**Meeting of the Central Valley Flood Protection Board  
November 16, 2012  
Staff Report  
County of Merced  
Canal Creek Bridge Crossing at Green Sands Avenue, Merced County**

Consider approval of Permit No. 18794 (Attachment B)

County of Merced

## GREEN SANDS BRIDGE

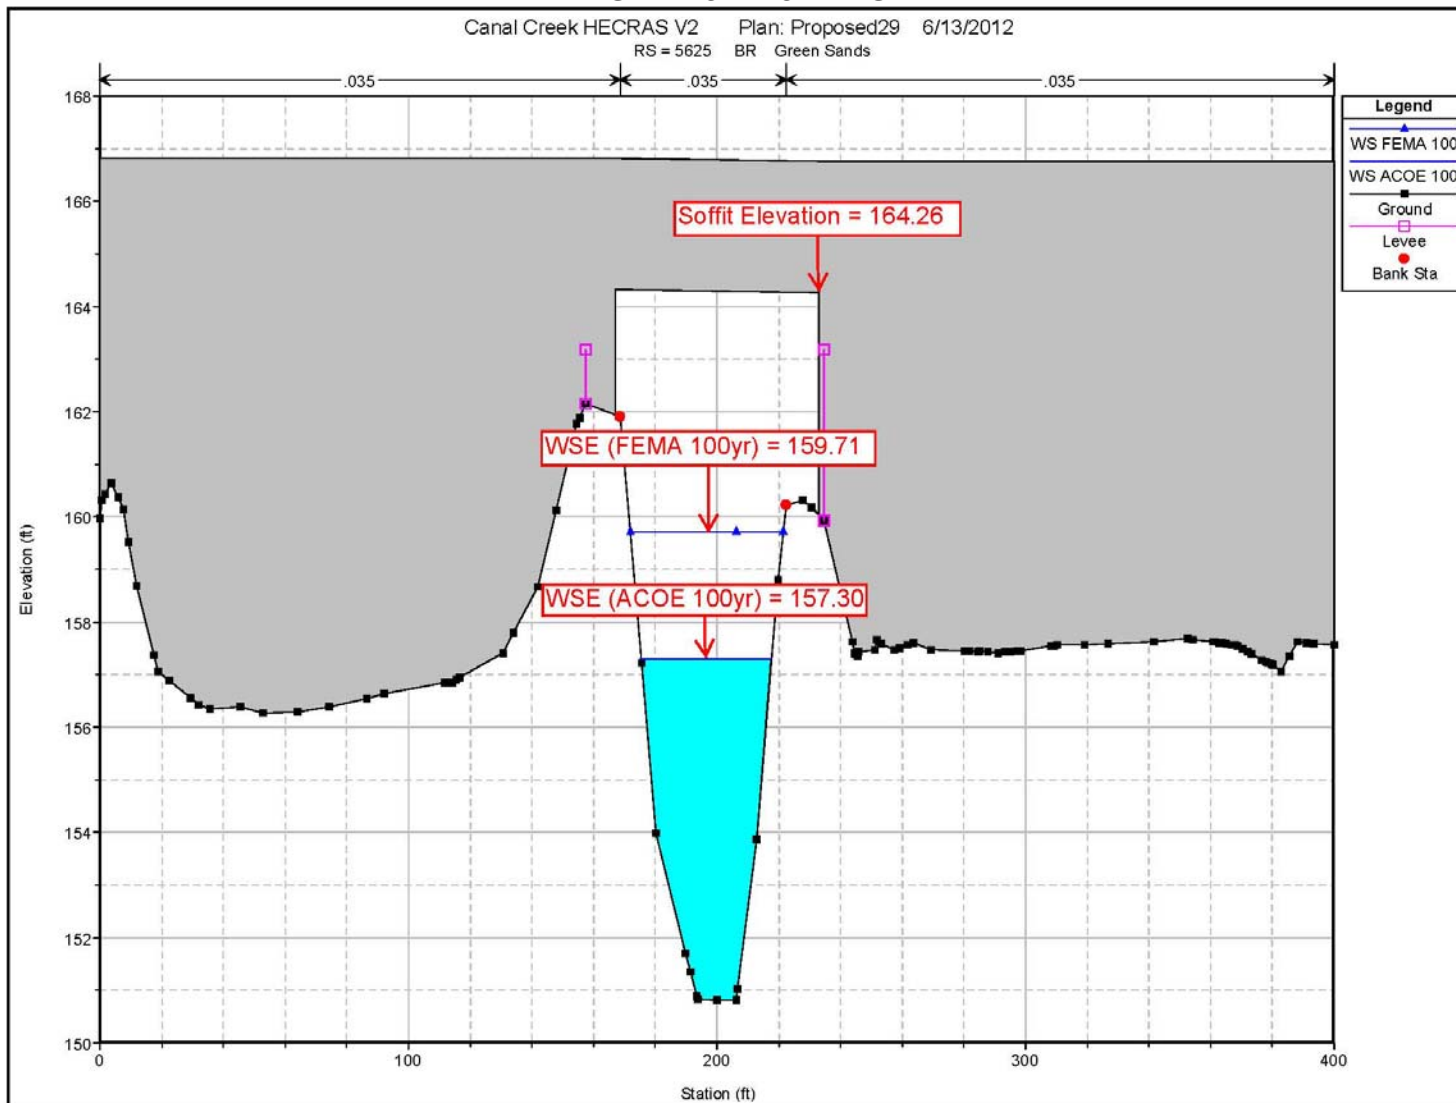
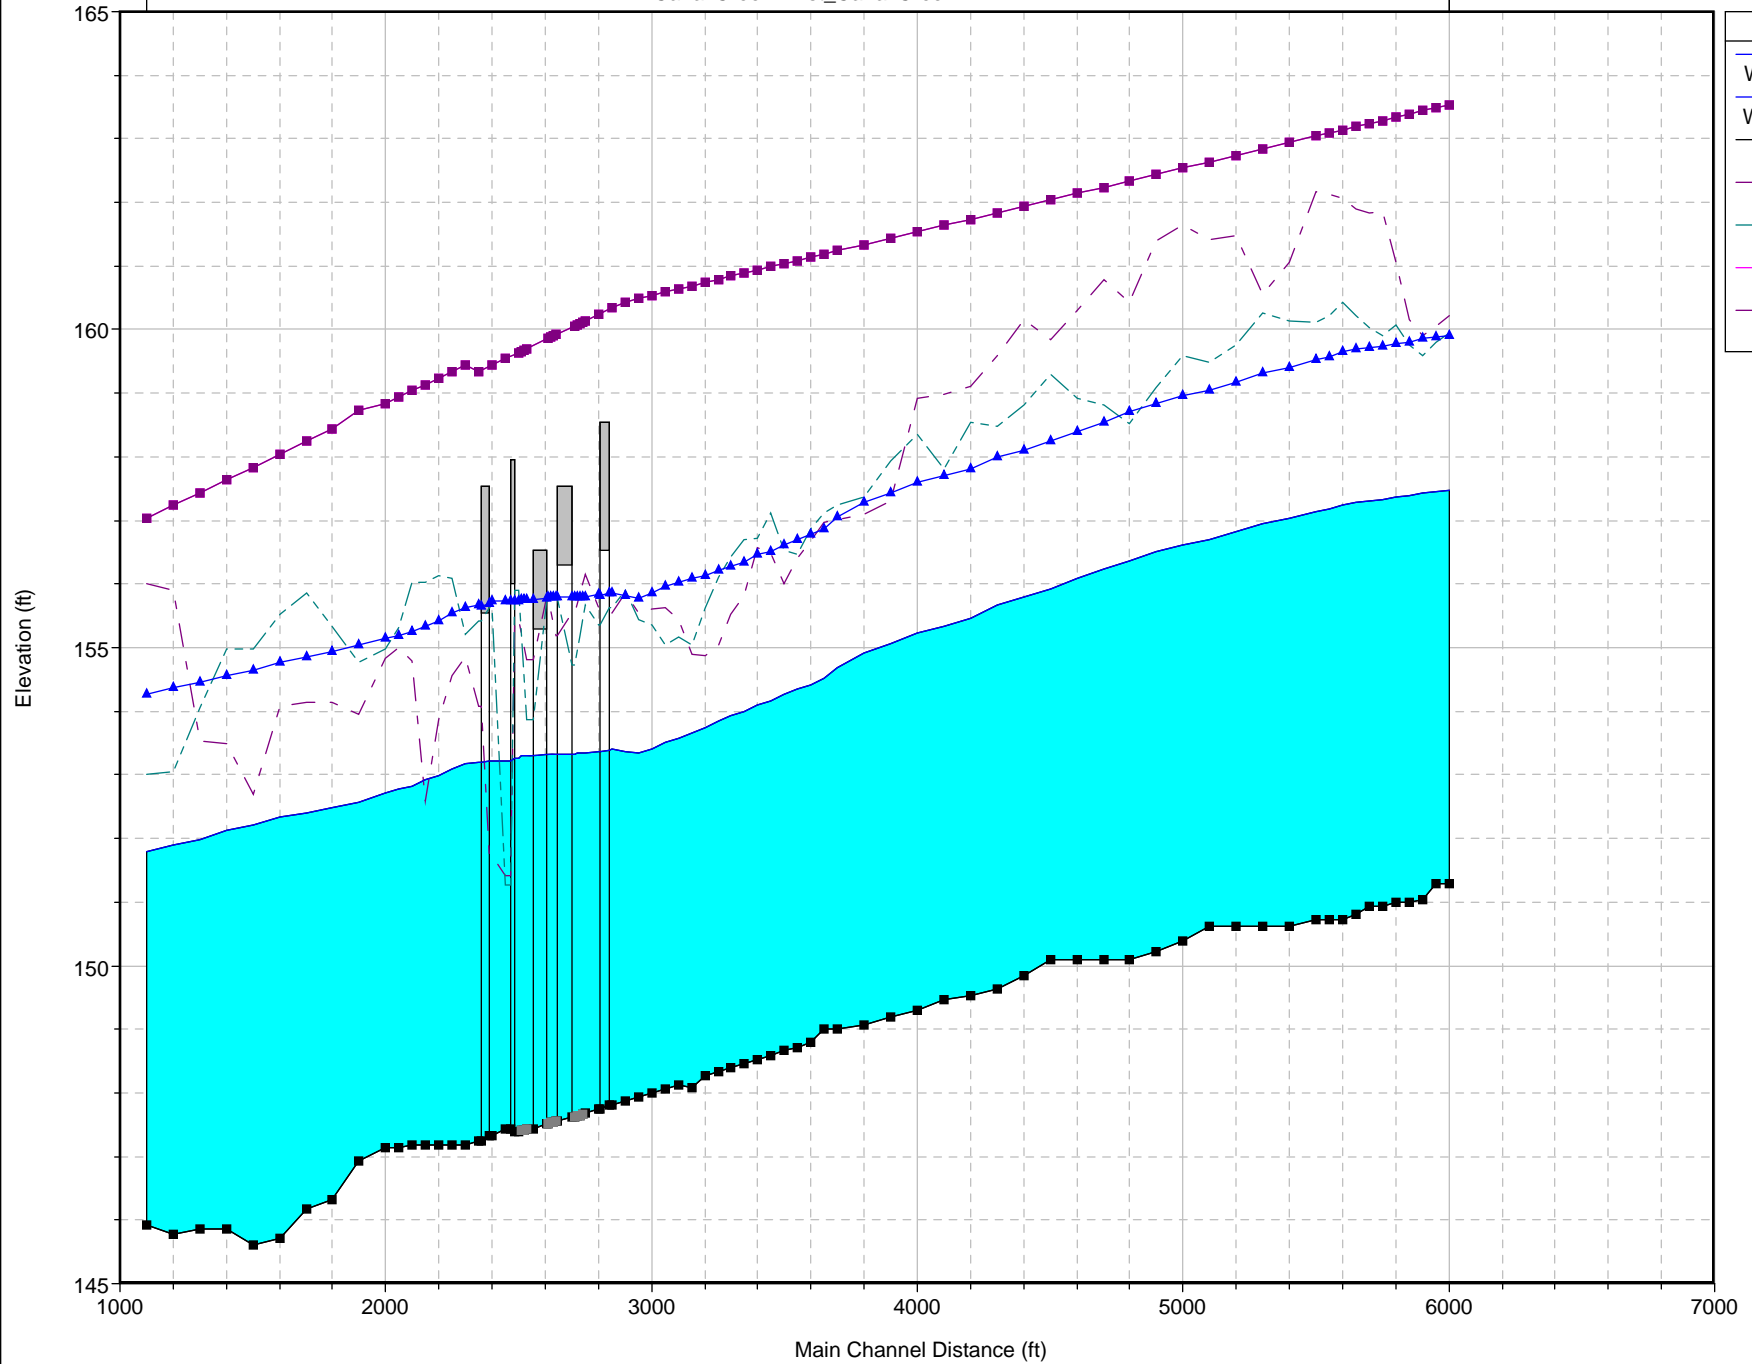
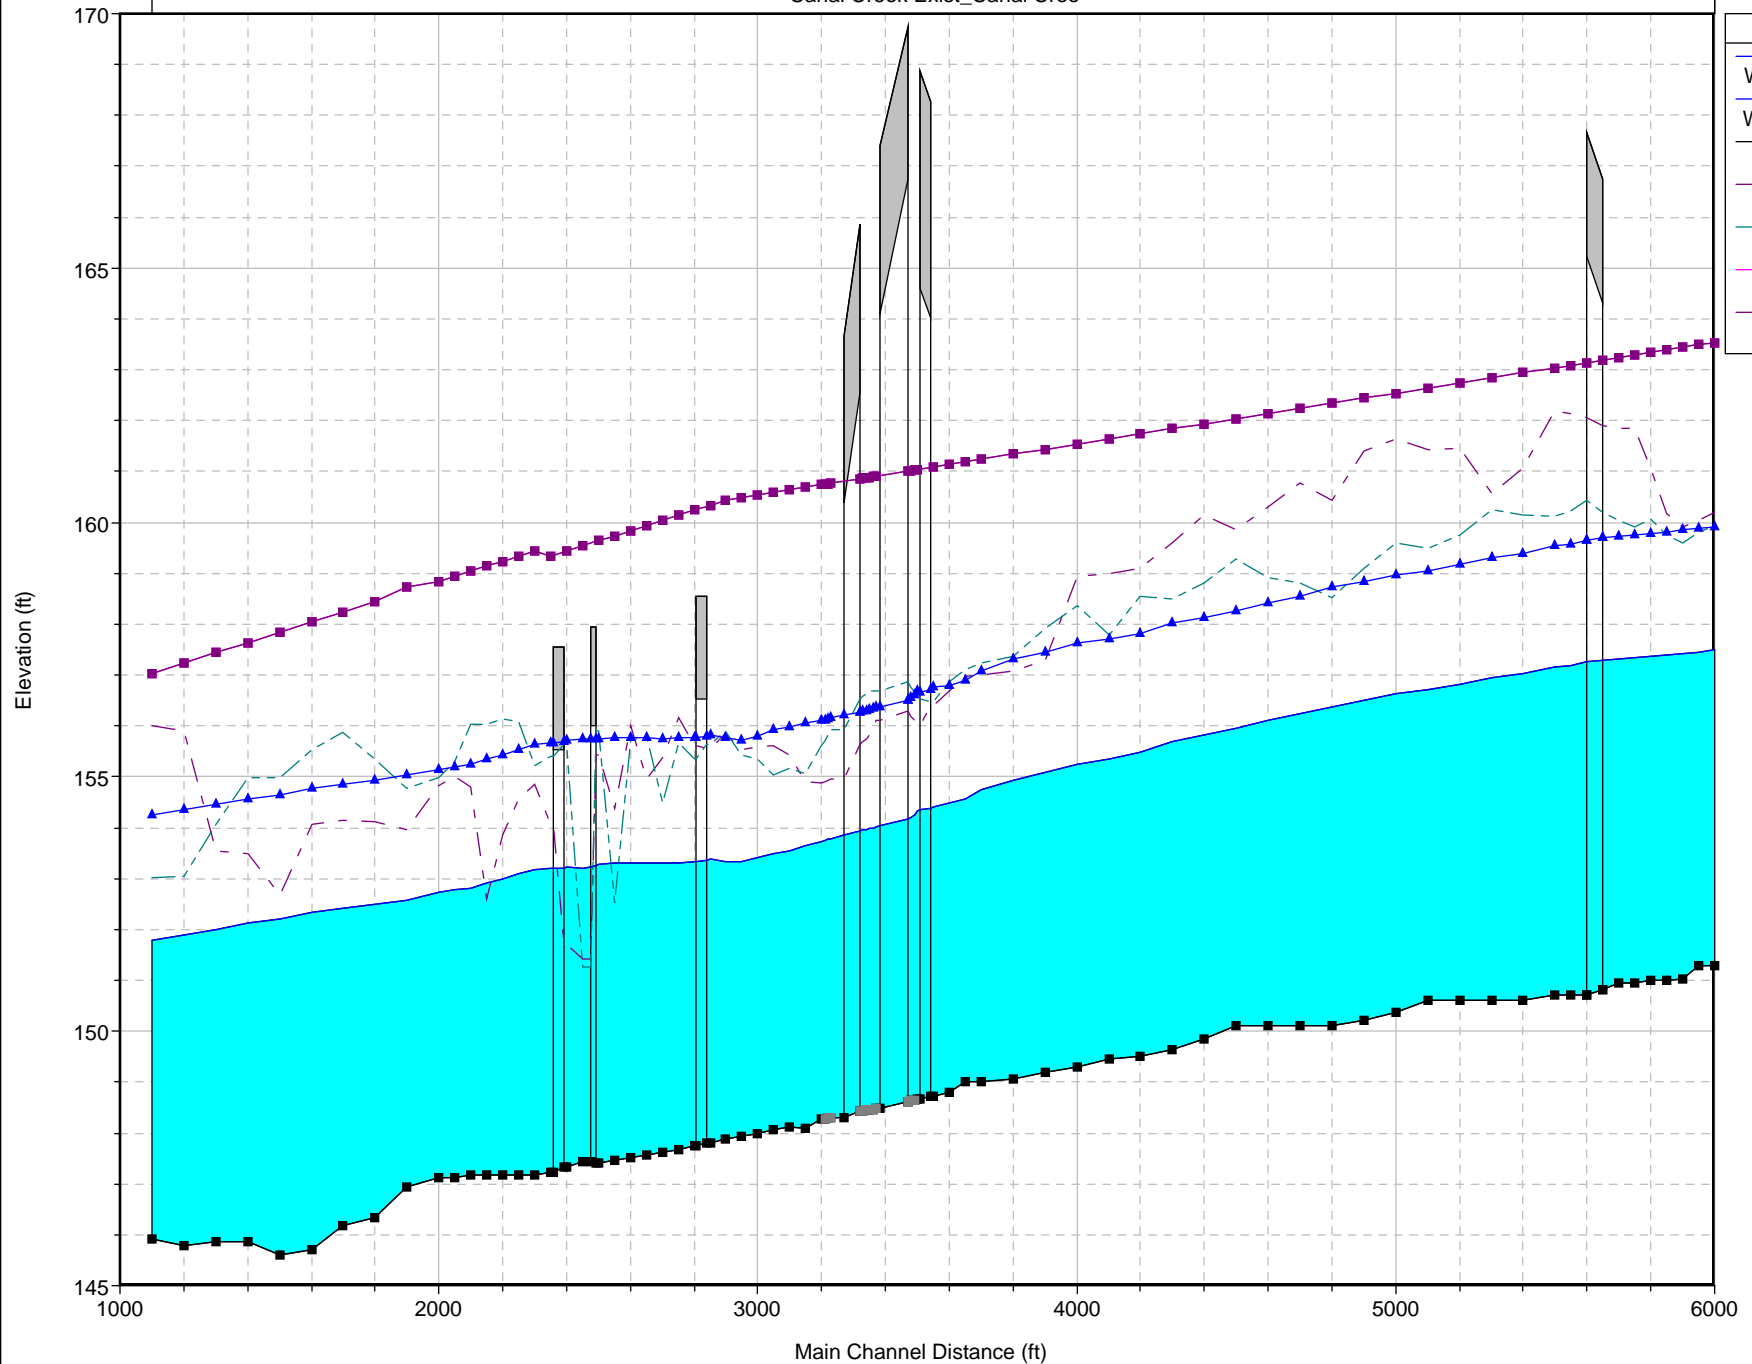
The modeling computed a 100-year WSE of 159.71 feet at the bridge. The proposed soffit of the new structure is at elevation 164.26 feet resulting in 4.55 feet of freeboard above the FEMA 100-year WSE and 6.96 feet above the USACE design discharge. This is consistent and compliant with CCR 23 standards which require a minimum of three (3) feet of freeboard above the design WSE.

Calculated velocities for the proposed project are approximately 3 feet-per-second (fps). The proposed project will result in a change in WSE of 0.01 feet from pre-project conditions. Staff agrees with the applicant's determination that the modeled impact of is negligible (see Attachment D – Hydraulic Profile and Summary Table).
